SWIM PROJECT PROFILE		Pilo No. : 166
Regist. No. : Agency No. : BSWM-80	Name: CAMBURAY SWIP	
Region: 4	Province: OCCIDENTAL MINDORO	Municipality: SAN JOSE
Present Status: 1. Pro-F/S() ② F/S(1985) ③ D/D(1985)		
Purpose: Major : Irrigation Incidental : IF, FC, WM		
Project Feature:

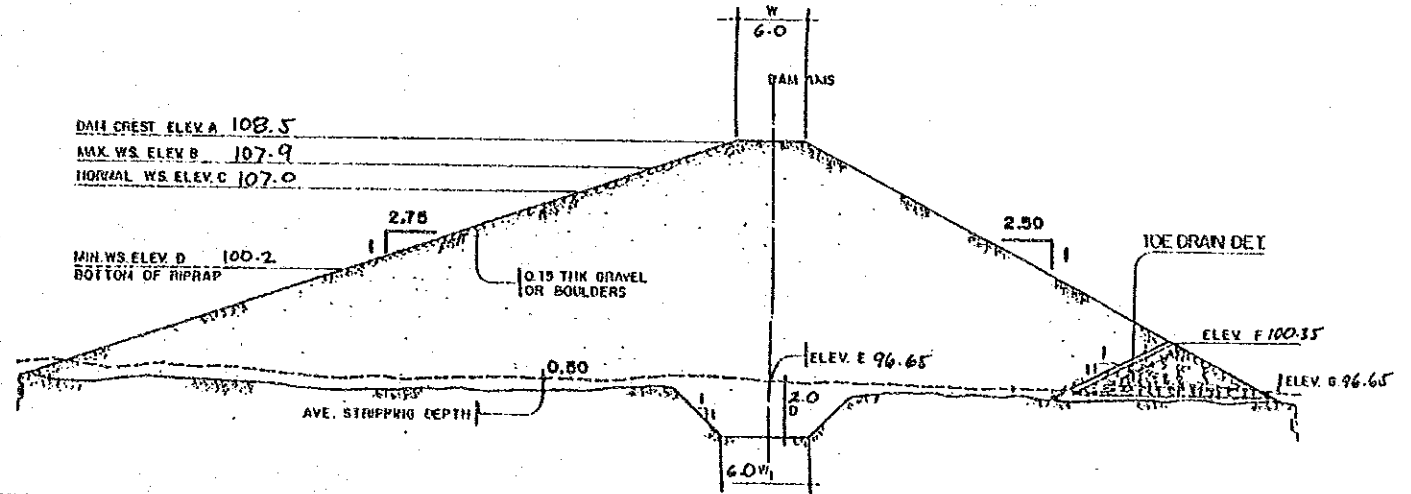
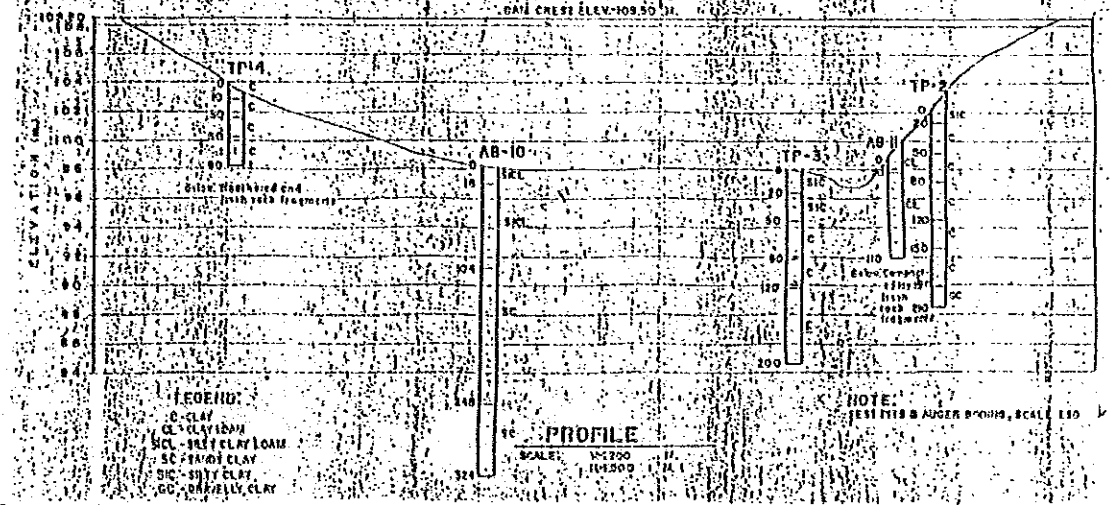
2. Planning		
Environmental conservation plan is not formulated.		
3. Design		
Depth of core trench shall be modified during construction.		
Stability of upstream slope shall be checked.		
Freeboard is not enough.		
Center line of the spillway shall be shifted to right side.		
Weir shall be provided in the spillway.

Note: Silty clay with 2.0 m depth is piled up on the sand stone and shale. Additional 0.5 m freeboard is necessary.

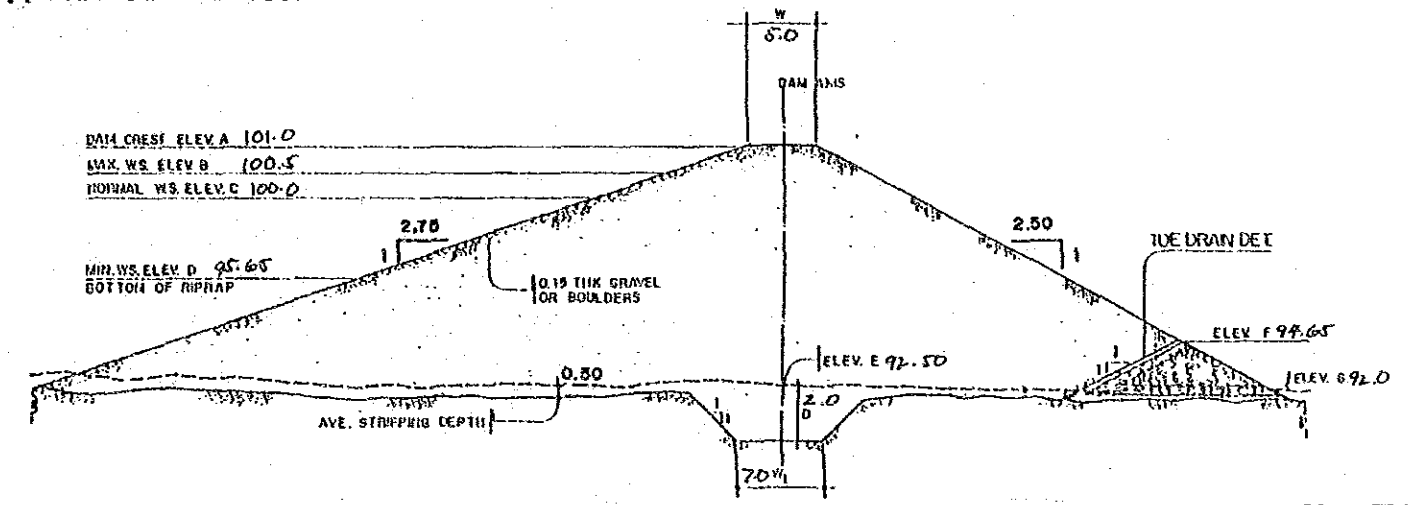
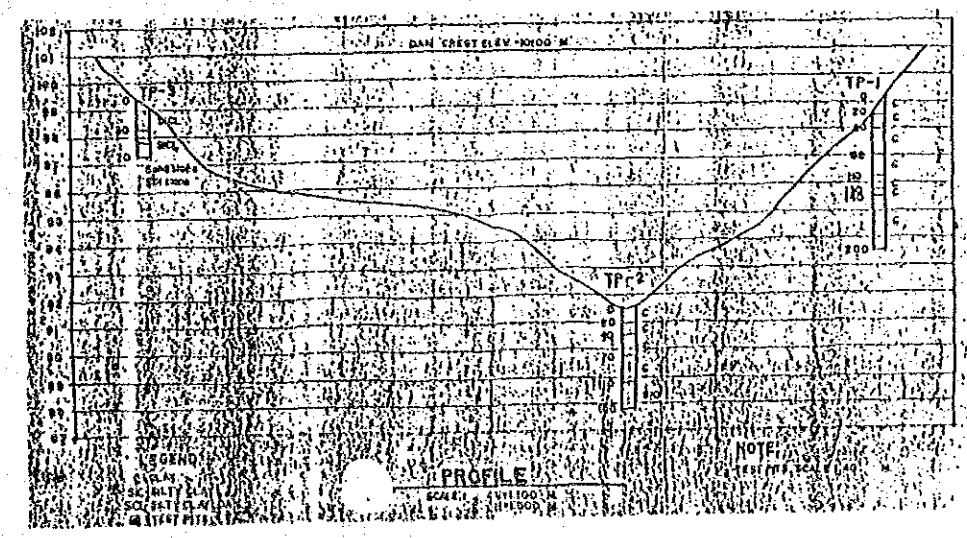
2. Planning Environmental conservation plan is not formulated. Project planning shall be re-formulated.		
3. Design Depth of core trench shall be modified during construction. Stability of upstream slope of the dam shall be checked. Freeboard is not enough. Weir shall be provided in the spillway.

Note: Clay blanket with 1.5 m depth is piled up on the sand stone and shale. Additional 0.5 m freeboard is necessary.

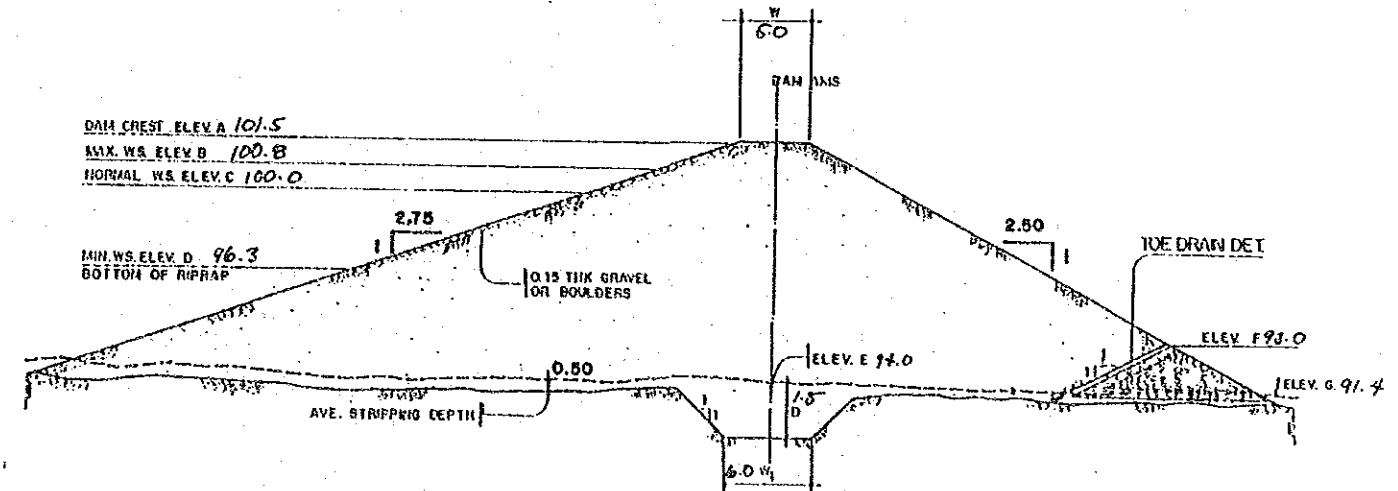
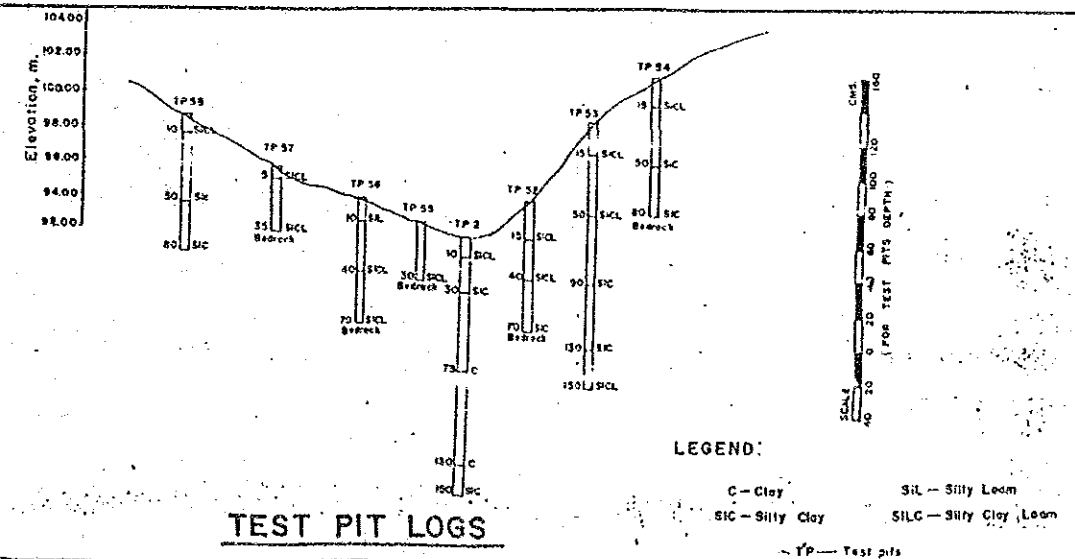
2. Planning		
Environmental conservation plan is not formulated.		
3. Design		
Depth of core trench shall be modified during construction.		
Stability of upstream slope of the dam shall be checked.		
Freeboard is not enough.		
Weir shall be provided in the spillway.

Note: Clay blanket with 1.5 m depth is piled up on massive, dense and indurated Basalt and Andesite. Additional 0.5 m freeboard is necessary.

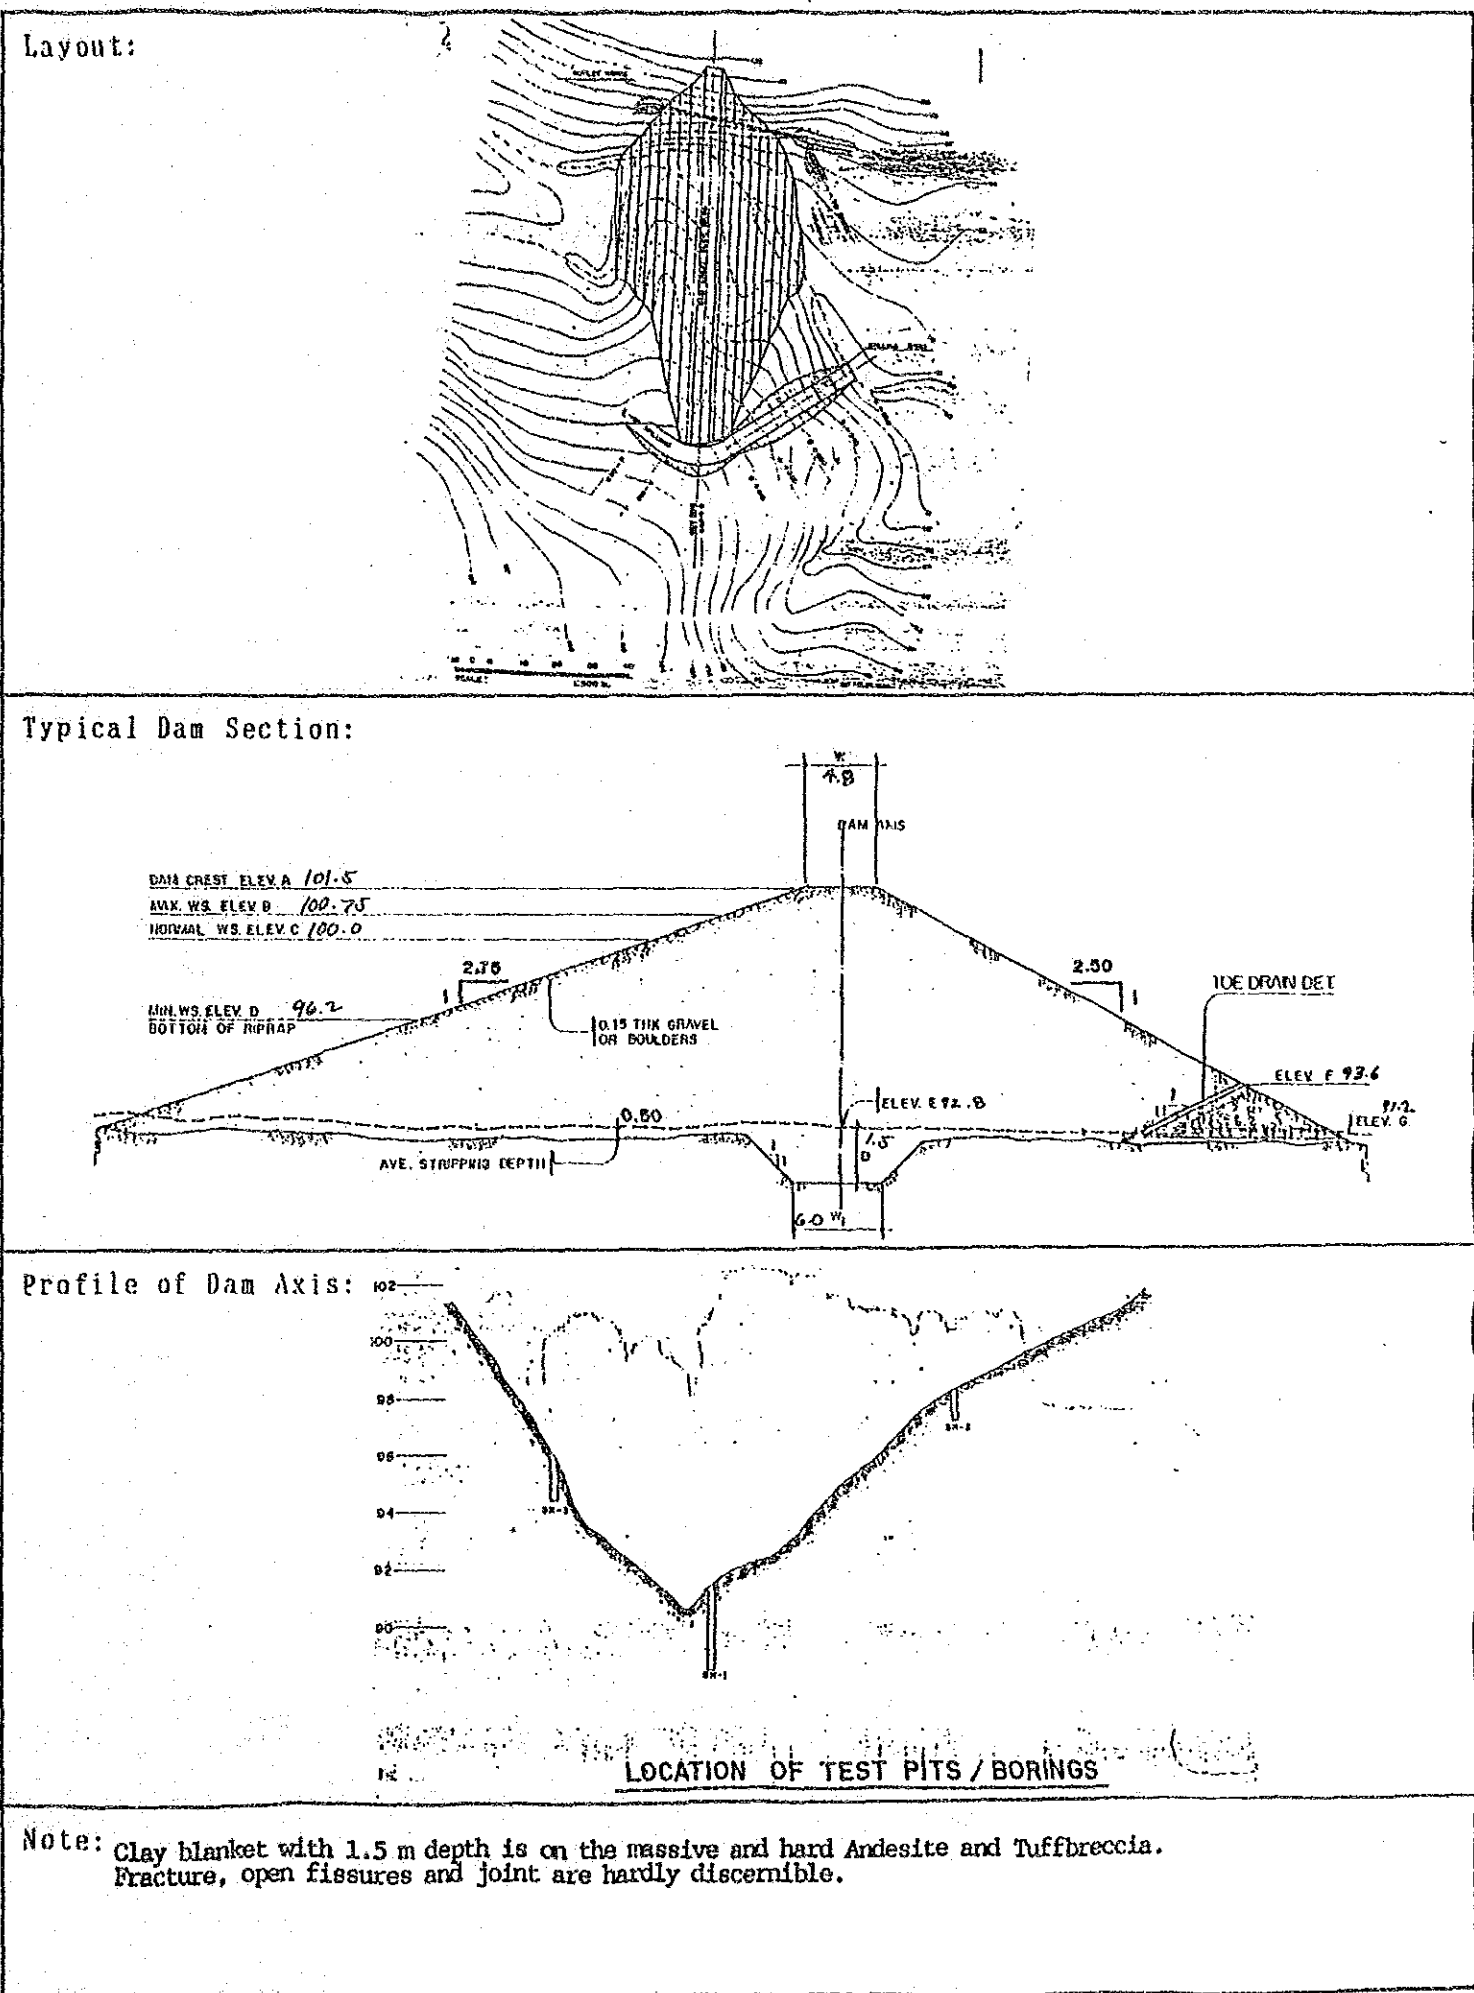
2. Planning Environmental conservation plan is not formulated.		
3. Design Depth of core trench shall be modified during construction. Stability of upstream slope shall be checked. Weir shall be provided in the spillway. Weir section is necessary in spill way. Center line of the spillway shall be shifted to right side.

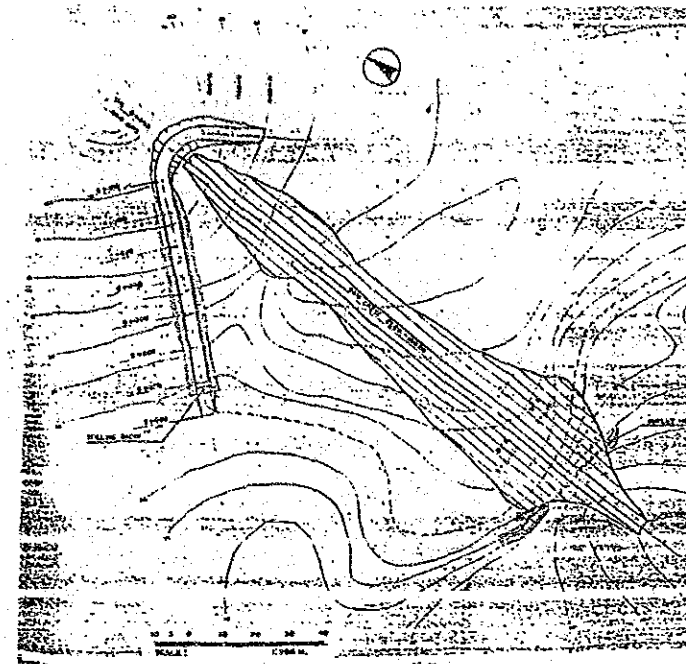
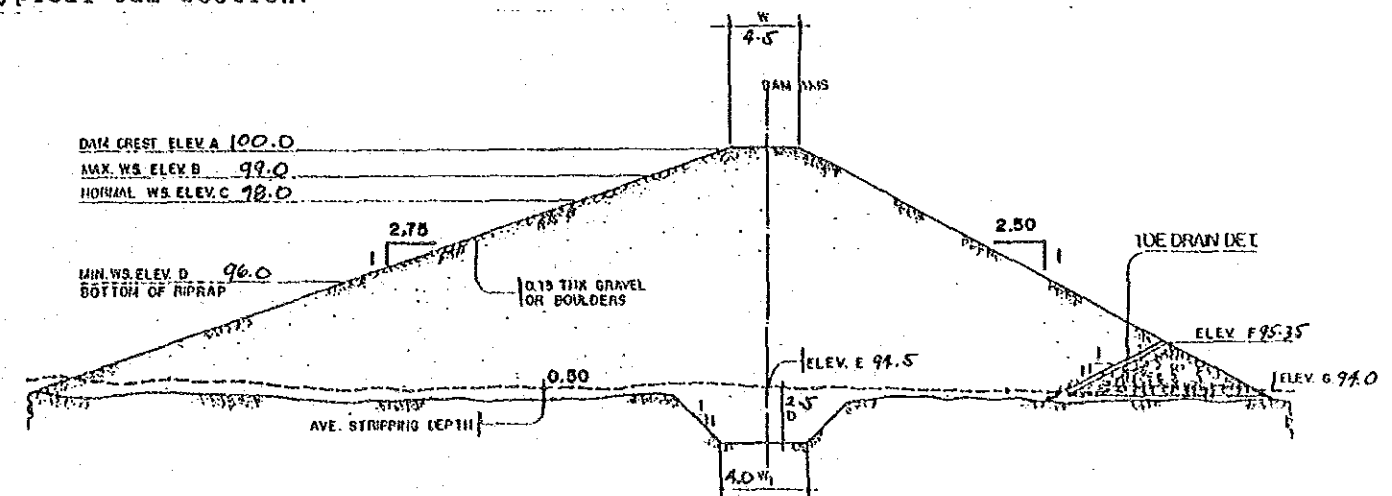
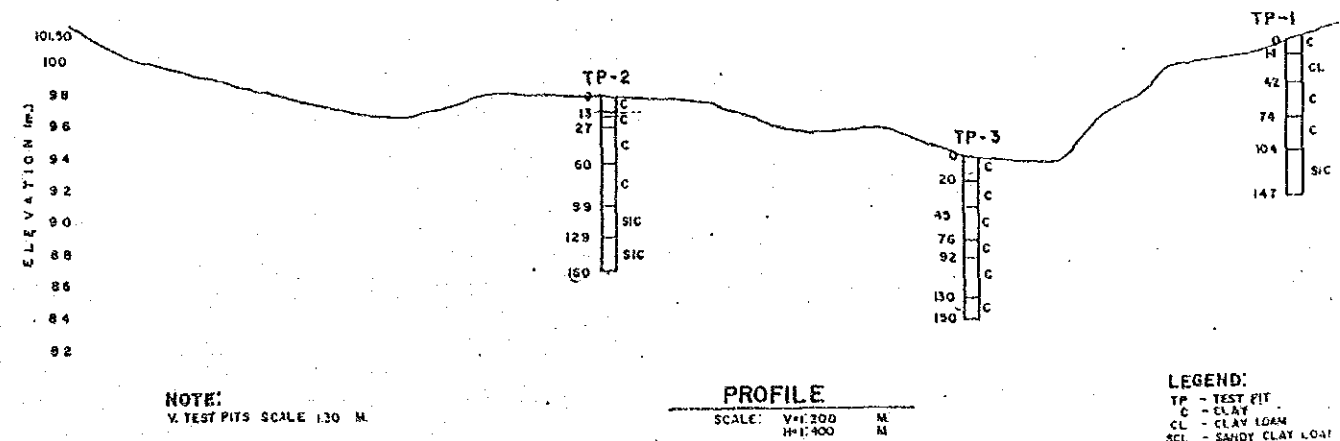
2. Planning Environmental conservation plan is not formulated.		
3. Design Depth of core trench shall be modified during construction. Stability of upstream slope of the dam shall be checked. Freeboard is not enough. Weir shall be provided in the spillway.

Note: Clay with 3.0 m depth is piled up on the sand stone and silty stone. Additional 0.5 m freeboard is necessary.
